Product Change Notice

PCN-147200

Carrier tape pocket design change

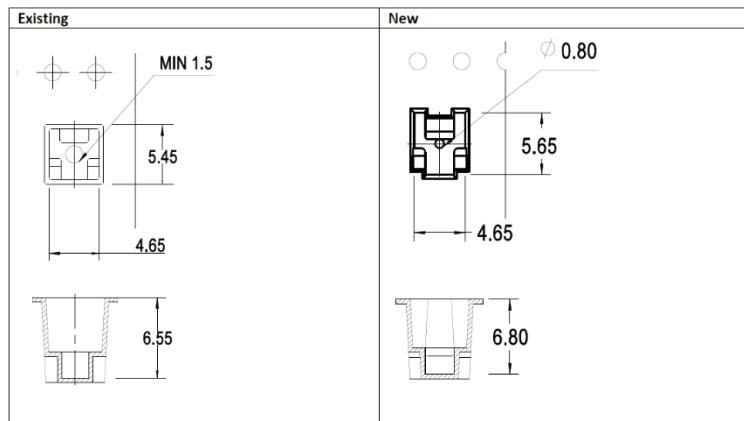
The carrier tape design will be modified for better LED fitting. The table below shows the comparison of the existing and new carrier tape design.

Improvement on the design of the carrier tape, which will allow a firmer positioning of unit inside the pocket.

The change is limited to the carrier tape design only. There is no change in the material of the carrier tape. There is no change in the fit, form and function of the device.
